DATE: June 15, 2006

FROM: Technical Service Dept. & Engineering Dept.

SUBJECT: SMC Solenoid Valve Replacements

Sample SMC
Solenoids

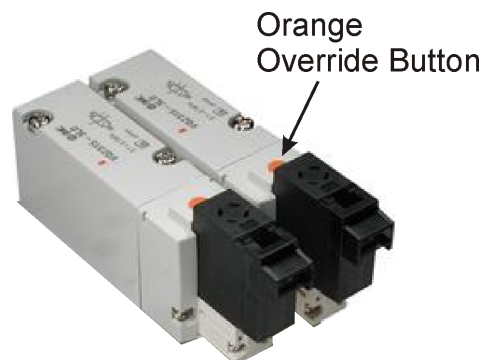
A number of special-series SMC solenoid valves were released from SMC under the same part number and they can be identified by their BLUE override buttons. The original SMC solenoids have an ORANGE override button. Unfortunately, the coils used in both configurations are not compatible. For that reason, Fischbein will stock the replacement coils for both the original and special-release solenoid versions. If you need a replacement or spare part for either solenoid version, please follow the chart below for the correct replacement part:

Replacement Part Number BLUE Override	Replacement Part Number ORANGE Override	Description
67918	67684	24VAC COIL
67919	67685	24VDC COIL
67920	67686	110VAC COIL
